Docket Item # 5
BAR CASE # 2009-0084

BAR Meeting
June 17, 2009

ISSUE: Permit to Demolish/Encapsulate
APPLICANT: Dominion Design Associates, LLC by Dennis Powell
LOCATION: 513 Duke Street
ZONE: RM/Residential

Figure 8. Existing elevations with dashed lines showing areas of demolition/encapsulation.

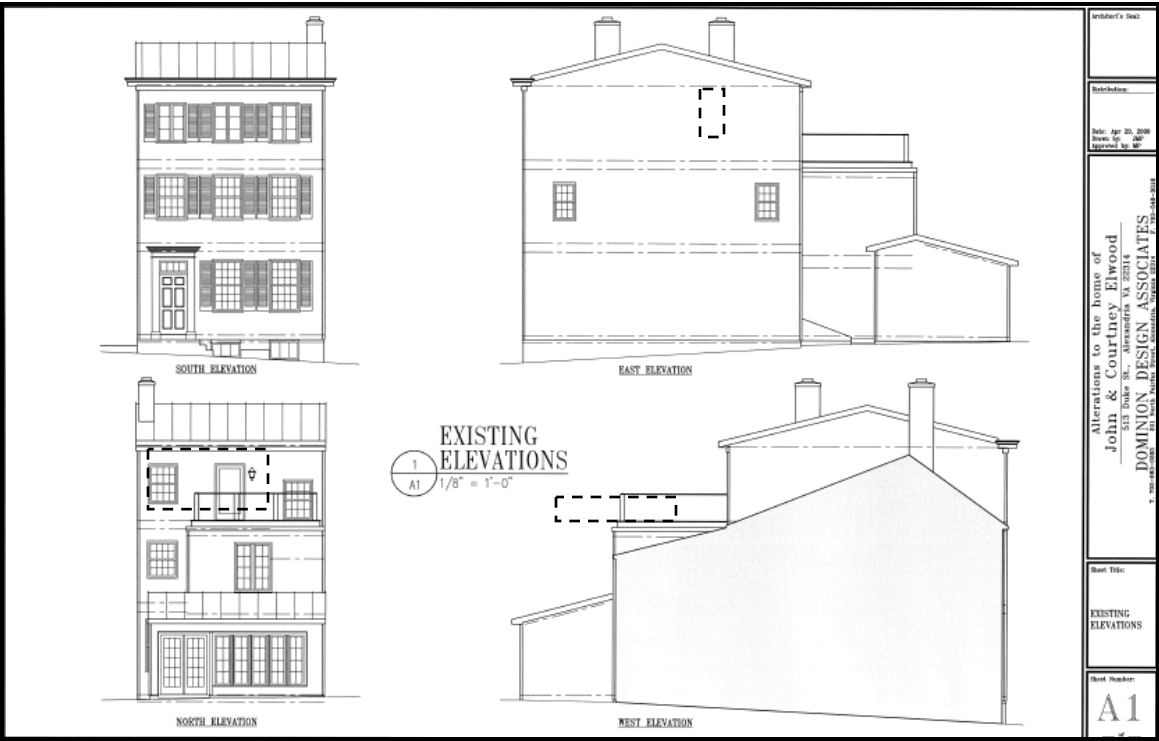
The applicant is requesting approval of a Permit to Demolish and Encapsulate in order to construct a third story addition and install a new window at 513 Duke Street. The addition will be constructed on the existing second floor roof deck and will tie into the main block of the historic house at the third story. A small 2.5 foot by 4.5 foot area on the east elevation is proposed to be demolished in order to install a new double-hung window at the third floor.

The total area of demolition and encapsulation is 294 square feet and is broken down as follows:

- the roof of the second story rear addition where the new addition will be constructed – 171 square feet;
- a portion of the third story rear (north) wall of the main building block where the addition will tie into the main house – 112 square feet;
- a portion of the rear of the main building roof to accommodate the new 2 foot high hip roof of the addition; and,
- the area on the east elevation where the new window will be installed -11 square feet.

In the opinion of Staff, none of the criteria are met for the proposed demolition and encapsulation. While Staff recognizes the building's importance to the early 19th-century residential housing stock, Staff finds the amount of proposed demolition and encapsulation small and does not compromise the architectural or historic integrity of the building. Staff does not object to the demolition of the 11 square foot section on the 1797 portion of the house because it is located on the third floor and is small in size. The flat roof of the second story rear addition where the new addition will be constructed is a later addition (1920s or 1930s) and is also not visible from a public right-of-way. The portion of the north wall of the main house which will be encapsulated was modified in 1992, when the BAR approved the installation of new insulation and wood siding; therefore, very little historic fabric remains on this elevation. The portion of the rear main roof that will be encapsulated is small and approaches the minimum roof necessary to support the addition.

Staff recommends approval of the Permit to Demolish/Encapsulate with the condition that the following archaeological conditions appear in the General Notes of all site plans and on all plan sheets that involve demolition or ground disturbance (including Basement/Foundation Plans, Demolition, Erosion and Sediment Control, Grading, Landscaping, Utilities, and Sheeting and Shoring) so that on-site contractors are aware of the requirements:
